SiD and MDI Meeting
CR-3 Implementation Plans and Intro to CR-4

V Kuchler
13 January, 2015

CHANGE REQUEST NO. ILC-CR-000N

DETECTOR HALL WITH VERTICAL SHAFT ACCESS

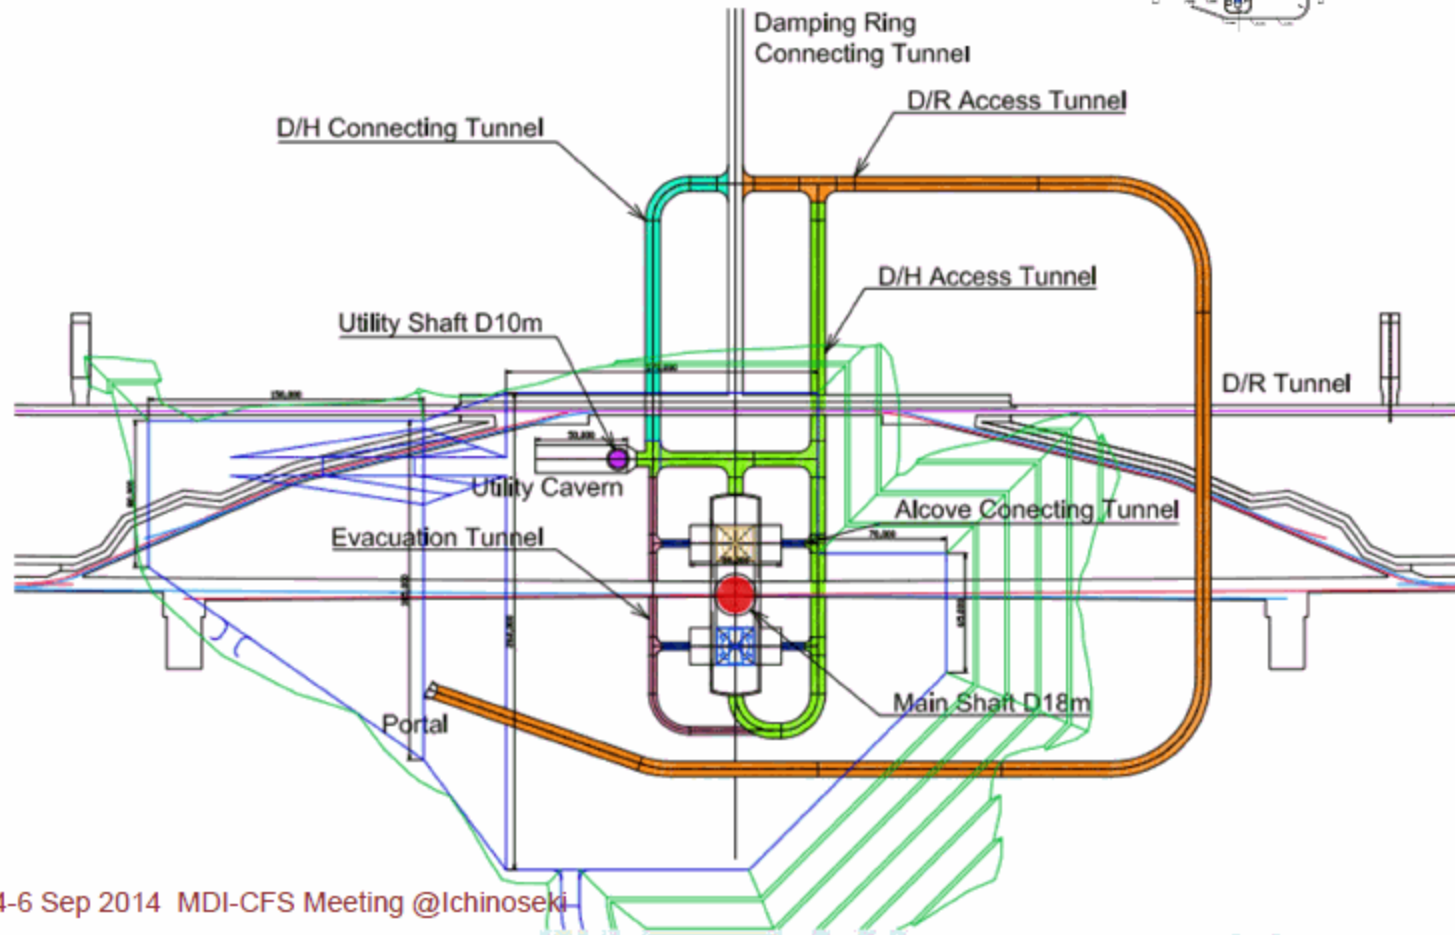
Change the underground experimental hall to a design that has a large vertical shaft and allows for the “CMS style” assembly of the detectors.

The baseline (TDR) design of the interaction region (IR) for the ILD in Japan foresees an underground experimental hall that can be accessed only via a horizontal O(1km) long tunnel with ~1 m diameter and a slope of O(7%). This has been defined before the Kitakami site has been selected for the ILC in Japan under the assumption that any Japanese site would be in a mountainous area that does not allow to have an assembly and maintenance area directly on top of the underground IR. The Kitakami site, however, allows to find a position for the IR that has a reasonably flat area above the IR and where a vertical shaft of O(100m) length could be built to access the underground areas.

Hybrid-A' General layout

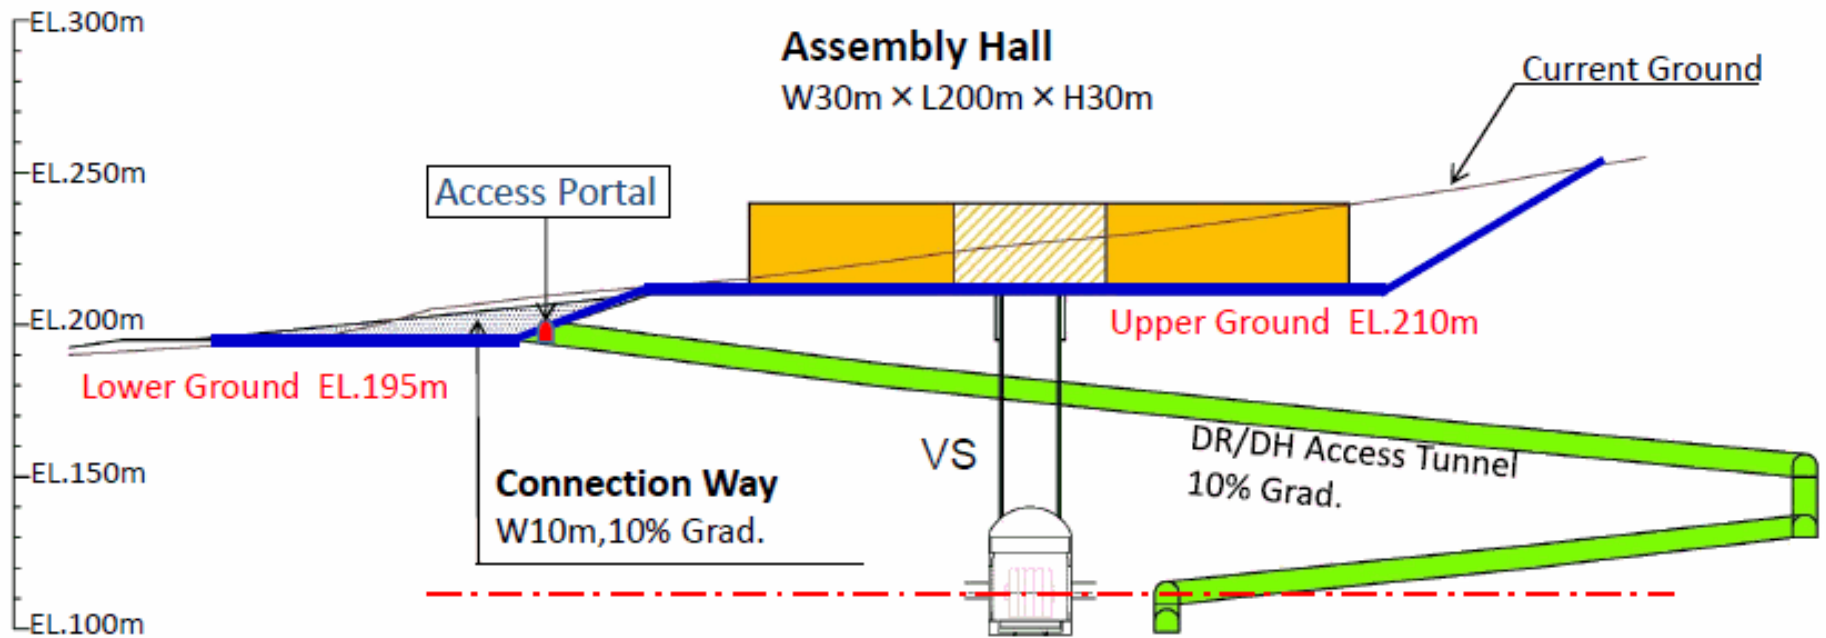
- **Implementation Team Named by CMB**
 - V Kuchler, K Buesser, T Markewicz, M Miyahara, J List, B List, T Sanuki
- **There are Complicating Factors**
 - TDR Contains Existing Drawings, Text and Cost Estimates
 - The Scope of CR-3 Includes a Change in the Detector Hall Design and Access as Well as a Change of Location
 - The Site has not yet Been “Officially Selected” by the Japanese Government as the Host Site
 - The Current Design will be Subject to More Changes Before a Complete Site Specific Design is Completed
 - The Change in the Detector Hall Location Will Affect One of More of the Horizontal Access Entry Locations and Overall Tunnel Lengths
 - How to Properly Document the Effect of the Approved Change is the Challenge at Hand

- **The Focus will be to Limit the Effort to the Detector Hall Area Only**
- **B List has Put Together a List of Affected Existing Documents**
- **These will Be Reviewed and an Evaluation of the Scope and Resources Needed will be Developed**
- **This is the First Change Request that has been Approved So We are Developing a Process**
- **A Method to Capture the Correct Amount of Documentation in EDMS will be Developed**

Where should the extra linac tunnel be inserted?

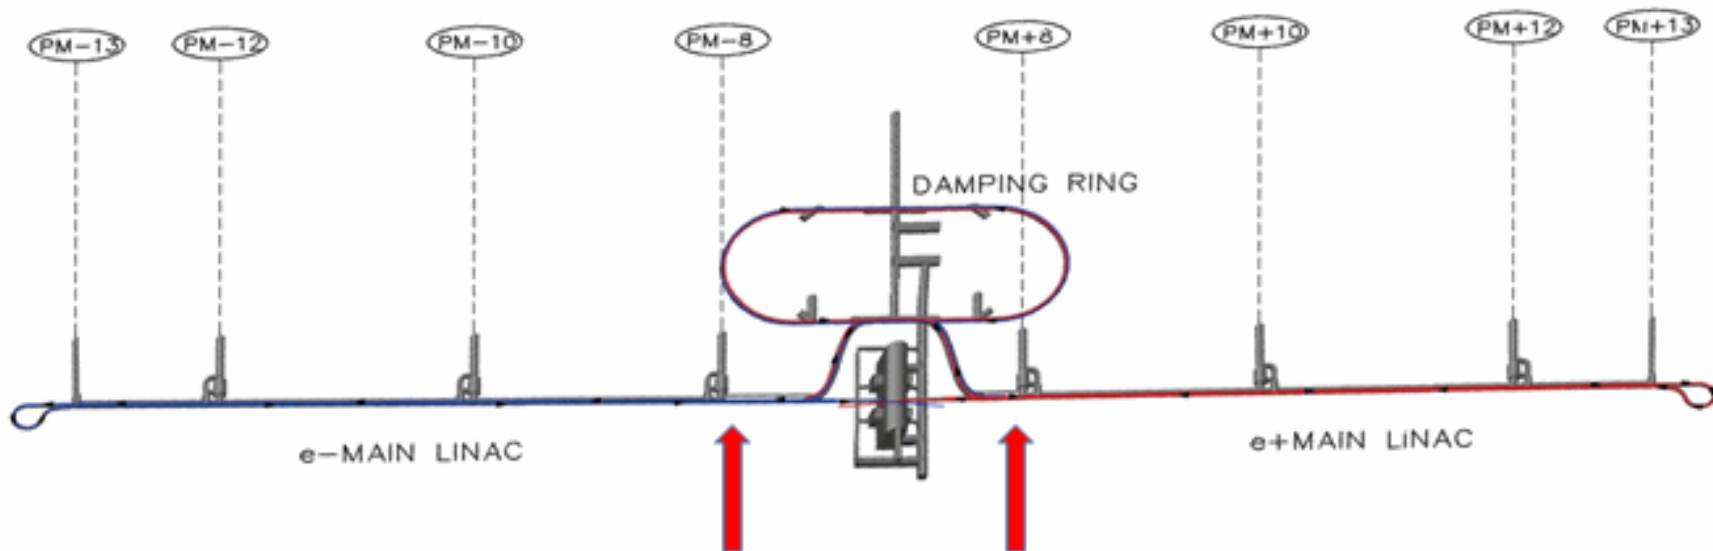
LINEAR COLLIDER COLLABORATION Designing the world's next great particle accelerator		
for official use only				
CHANGE REQUEST NO. ILC-CR-0004	EDMS No: D*01092915	Created: 18-12-2014		
		Last modified: 18-12-2014		
EXENSION OF THE ELECTRON AND POSITRON MAIN LINAC TUNNELS BY APPROXIMATELY 1.5 KM				
It is proposed to extend both the electron and positron main linac tunnels by approximately 1.5 km (total machine length approximately 3 km). For the baseline the additional tunnel length will be filled with simple passive beam transport lines.

- High energy ends of linacs
 - ✓ Cryogenics station at PM+8 can be reinforced later
 - ✓ Additional access tunnel not needed
